**To:** Kristopher Byrd, Well Construction and Compliance Section Manager  
**From:** Travis Kelly, Well Construction Compliance Coordinator  
**Subject:** Review of Water Right Application G-19194  
**Date:** February 3, 2022

Application # G- 19194

TO: Water Rights Section Date 11/29/2021  
 FROM: Groundwater Section Darrick E. Boschmann  
 Reviewer's Name  
 SUBJECT: Application G- 19194 Supersedes review of NA  
 Date of Review(s)

### Water-Level Measurements in Nearby Wells

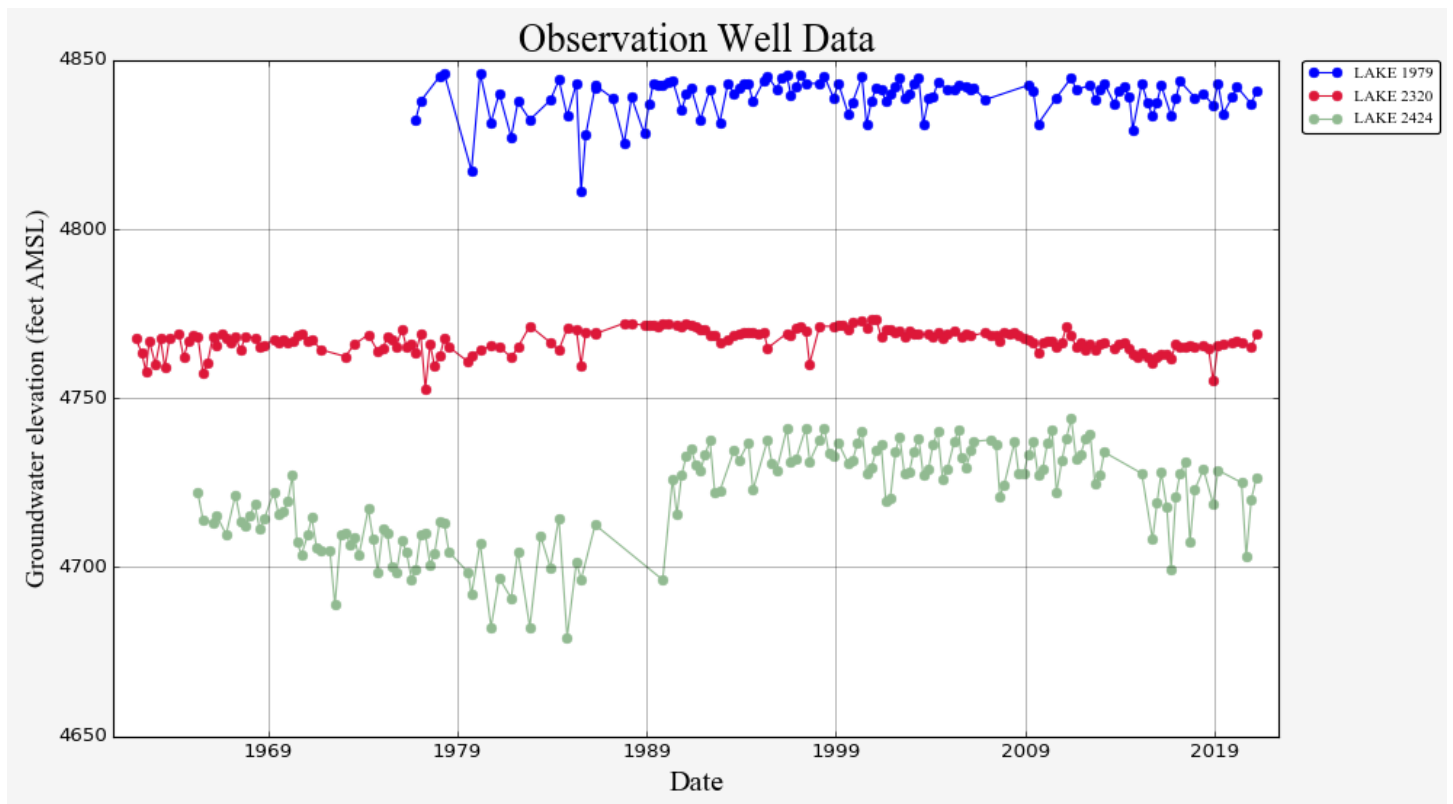
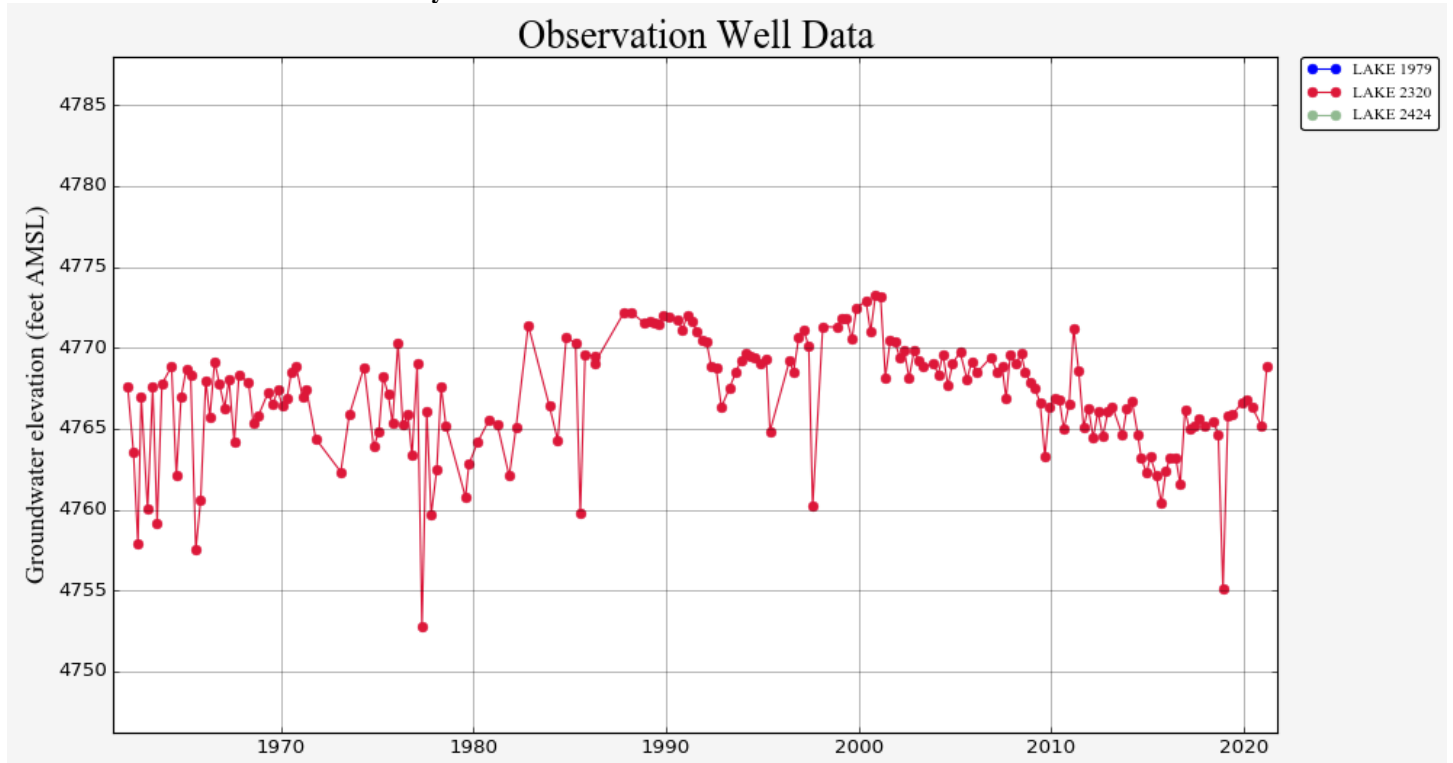
The nearest current state observation well LAKE 2320 is located over 2.5 miles to the southeast of the proposed well. This well is 110 feet, completed in basin fill, and has a water level record from 1962 to 2021. Overall the record depicts no indication of a long term year-to-year decline trend over the period of record. Other state observation wells in the Goose Lake subbasin (LAKE 1979, LAKE 2424) similarly show no indication of long term year-to-year decline trend over the period of record.

**Theis Time-Drawdown Worksheet** v.3.00

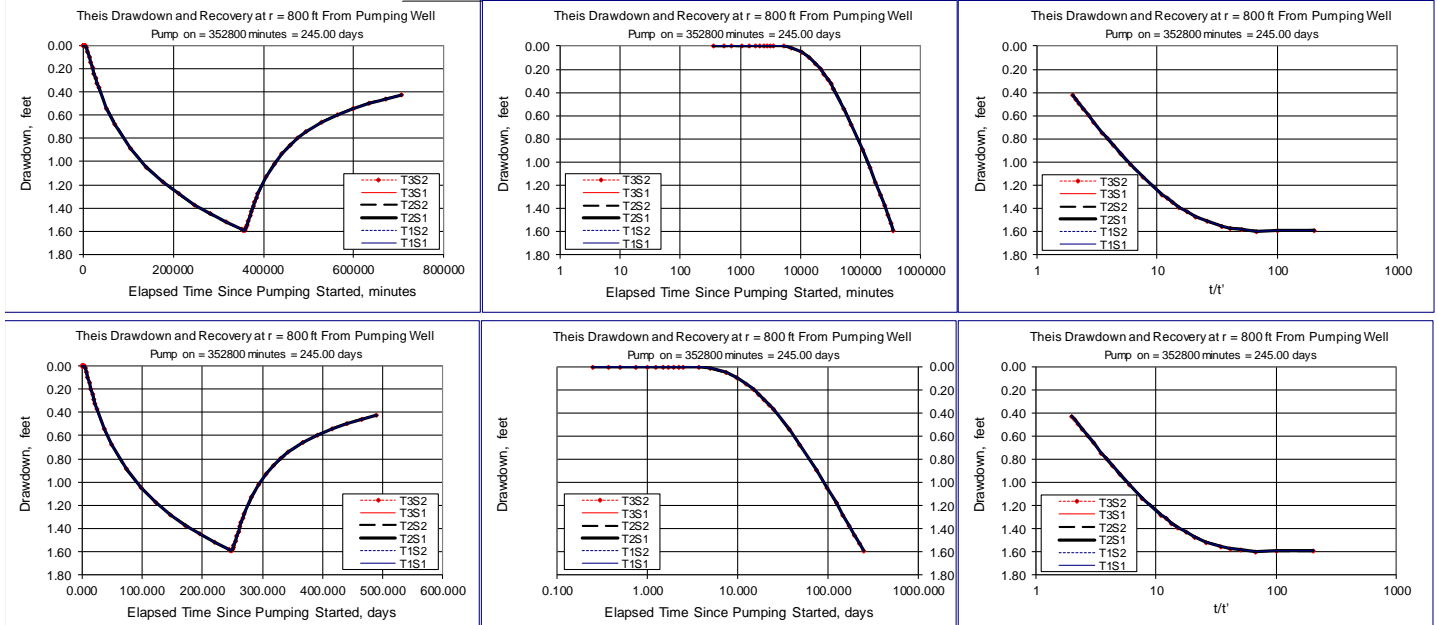
The nearest authorized POD to the proposed well is POD 1 under certificate 60743 (a sump) which is located ~800 feet to the southeast. The potential increase in seasonal interference was calculated using the Theis equation (see attachment). The transmissivity used in the calculation (1340 ft<sup>2</sup>/day) is the mean transmissivity of model layer 1 (basin fill) of Morgan, 1988. The storage coefficient used (0.1) is the value used by Morgan (1988) for model layer 1 (basin fill). At the maximum pumping rate (0.124 cfs) the results indicate an increase in seasonal drawdown of ~1.6 ft.

G-19194 Well 1 - SW1

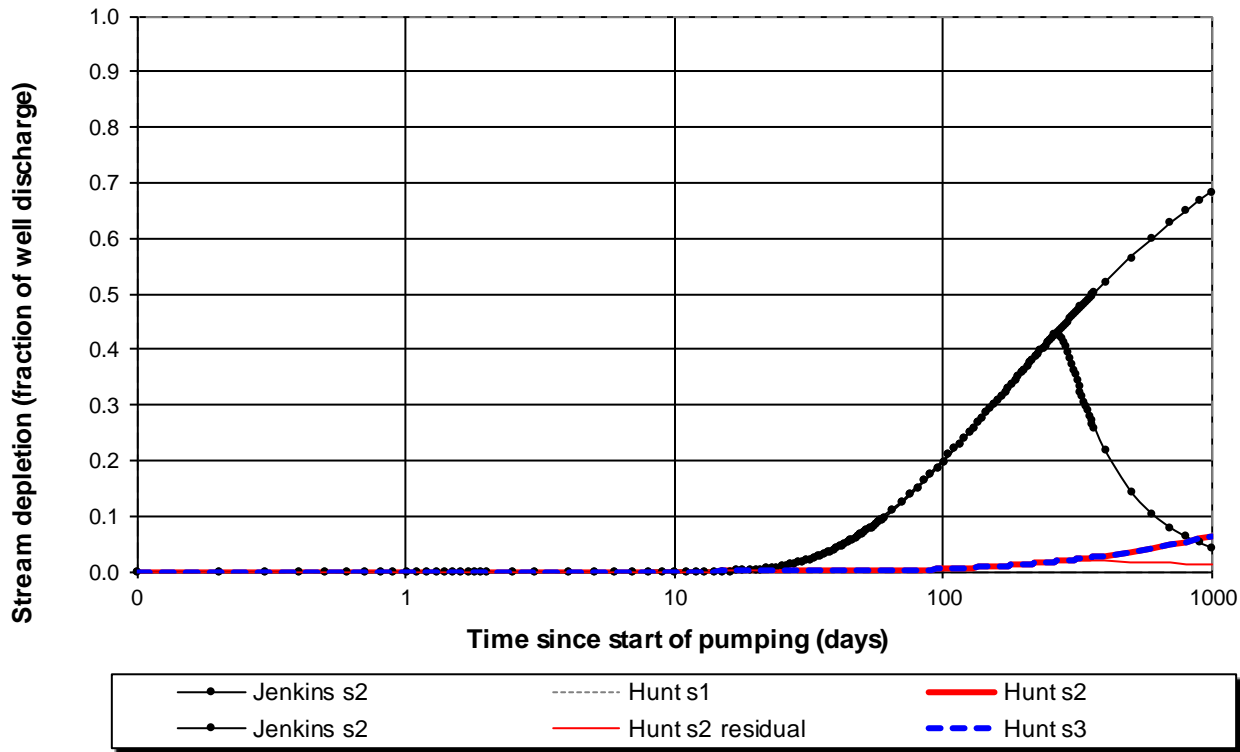
C3a. Hunt (1999) was used to calculate the interference between well 1 with SW1 and SW2. The values used for the calculation are conservative and appropriate until better values become available. The calculations used a transmissivity of 1340 ft<sup>2</sup>/day, the mean transmissivity of model layer 1 (basin fill) of Morgan, 1988. The storage coefficient used (0.1) is the value used by Morgan (1988) for model layer 1 (basin fill). The hydraulic conductivity assigned to the streambed is 0.023 feet/day. See reports attached.

**\*Qw is greater than 1% of 80% natural flow for both SW 1 and SW2.**

PSI is assumed for Well 1 to SW #1 and Well 1 to SW #2.
